Access Compliance Report

Public Rights-of-Way

(Curb Ramps)

Intersection ID: 12335	Main Street: MORTON_ST	Cross Street: W_MOREHEAD_ST	Location:	N
ADA ID: 56540797391A	Ramp Type: PerpDiag	Initial Pass/Fail: Fail	Overall Compliance: No	Severity Score: 27.5
Codes/Mitigation Info/Possible Solution		Field Measurements/Component Compliance

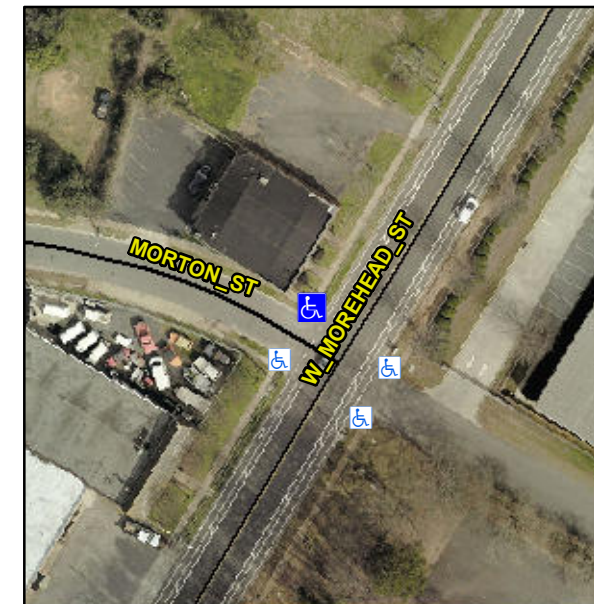
Remove & Replace Curb Ramp With Two New Directional Ramps or Equivalent.

R304.2.2, R302.7

Compliance	Description	Data	Compliance	Description	Data
N/A	Ramp Length (in)	58.0	No	Ramp Slope (%)	9.2
Yes	Ramp Width (in)	52.0	Yes	Ramp XSlope (%)	1.4
N/A	Flare Type LT	N/A	N/A	Flare Type RT	N/A
N/A	Flare Slope LT (%)	N/A	N/A	Flare Slope RT (%)	N/A
N/A	Flare Traversable LT?	N/A	N/A	Flare Traversable RT?	N/A
N/A	Landing Length (in)	N/A	N/A	DWS Provided?	N/A
N/A	Landing Width (in)	N/A	N/A	DWS Contrast?	N/A
N/A	Landing Slope (%)	N/A	N/A	DWS Length (in)	N/A
N/A	Landing X Slope (%)	N/A	N/A	DWS Full Width?	N/A
N/A	Landing Curb? (Y/N)	N/A	N/A	DWS Offset (in)	N/A
N/A	Shared Landing?	N/A			
N/A	Gutter Ponding?	N/A	N/A	Gutter Slope (%)	N/A
N/A	Gutter Lip Ht (in)	N/A	N/A	Gutter X Slope (%)	N/A
N/A	Painted X Walk1?	No	N/A	Painted X Walk2?	No
	X Walk 1 Direction	To SW		X Walk 2 Direction	To SE
N/A	X Walk 1 Width (in)	N/A	N/A	X Walk 2 Width (in)	N/A
	X Walk 1 Slope (%)	3.0		X Walk 2 Slope (%)	4.6
	X Walk 1 X Slope (%)	2.7		X Walk 2 X Slope (%)	1.6
